DATE ~~R~~ Mar.12/03**V2500-D5 NACELLE SERVICE BULLETIN**

This document transmits Revision 1 to Service Bulletin NV2500-78-0170 and
 Revision 1 to the Supplement

Reason for change
 To revise kit contents and
 make related changes to
 text and illustration.

NACELLE - EXHAUST - TRANSLATING SLEEVE AFT LATCH, HEAT SHIELD MODIFICATION/LATCH
ACCESS DOOR HINGE MODIFICATION, THRUST REVERSER

Latch Access Door Hinge Point Attach Hardware
Figure 6 (Sheet 1)

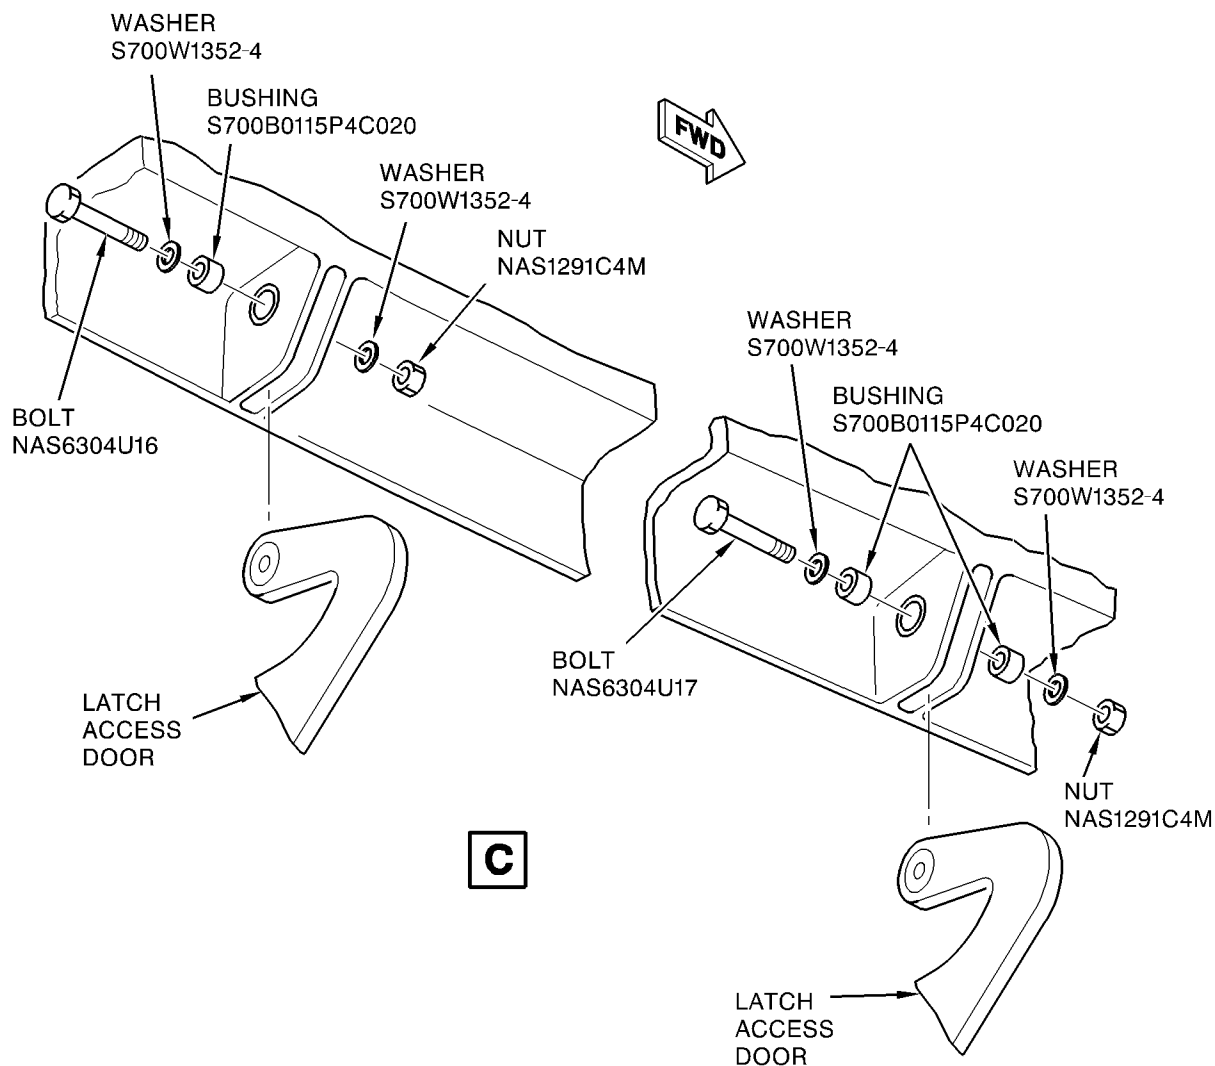
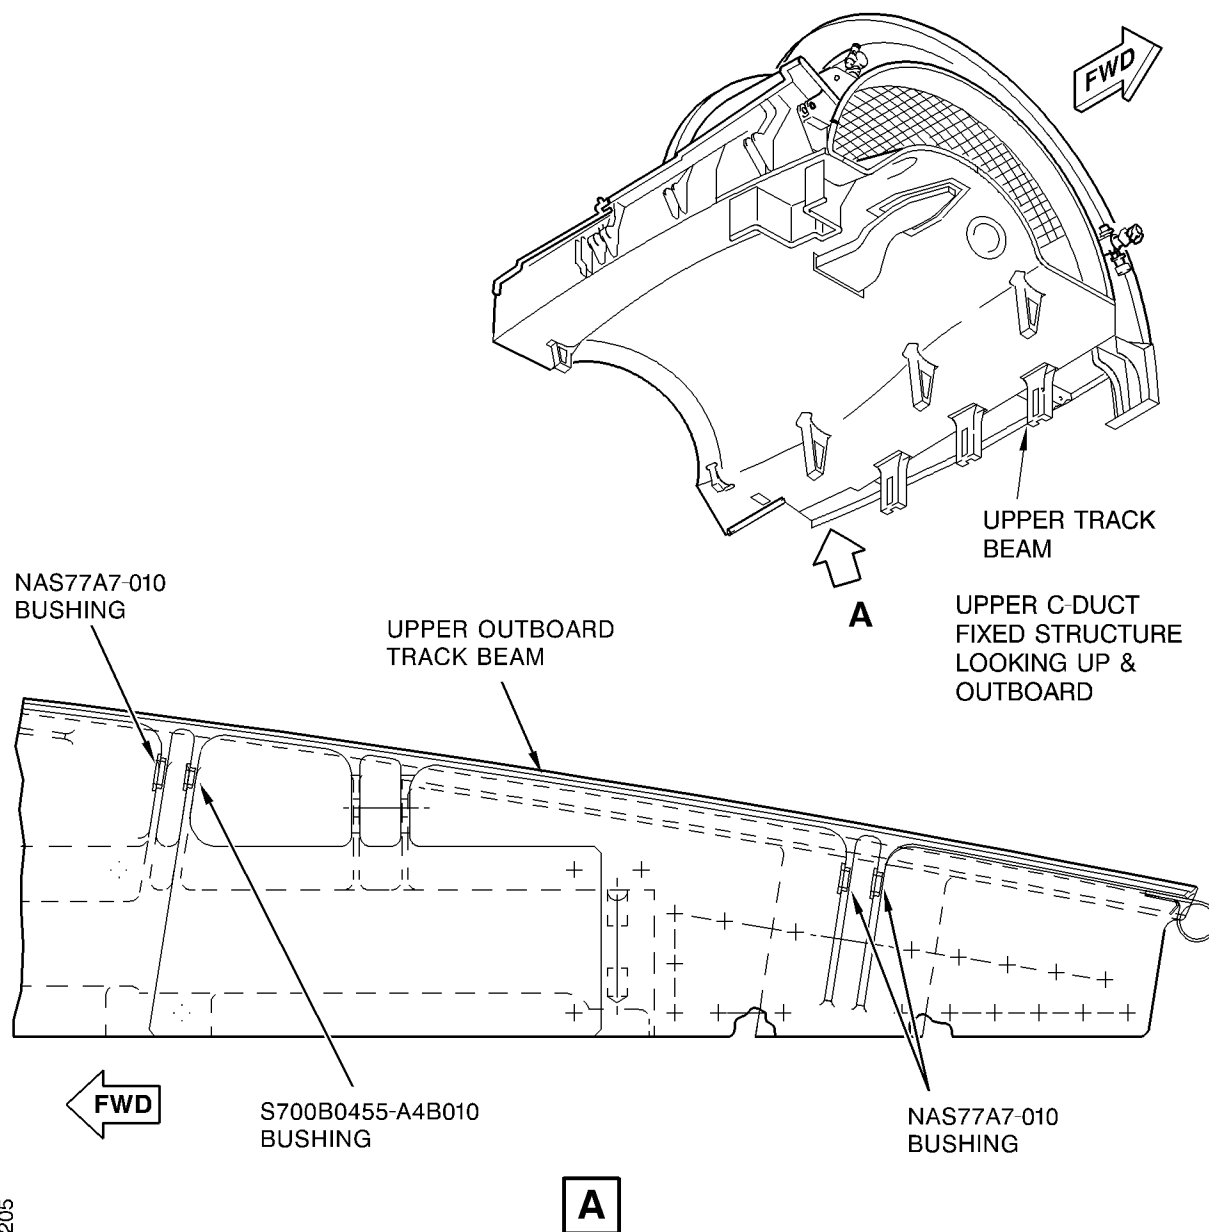
- (9) Install the latch access door. Refer to the MD90 Aircraft Maintenance Manual, Chapter 78-32-09, Page Block 401. Make sure all the track beam bushings and door installation bushings are present and installed correctly. Refer to Figure 6.
- (10) Check for too much looseness or 'free-play' at the latch access door attach points.

- (a) If there is too much looseness or 'free-play', check for proper installation of the attach hardware and replace any worn, damaged, or missing bushings. Refer to Figure 6.
- (11) Adjust the latch access door aft seal. Refer to Figure 5.
- (a) Loosen the nuts and move the 290-0038-23 aft seal until it is compressed 10% to 30% against the translating sleeve when the latch access door is closed. Tighten the nuts.
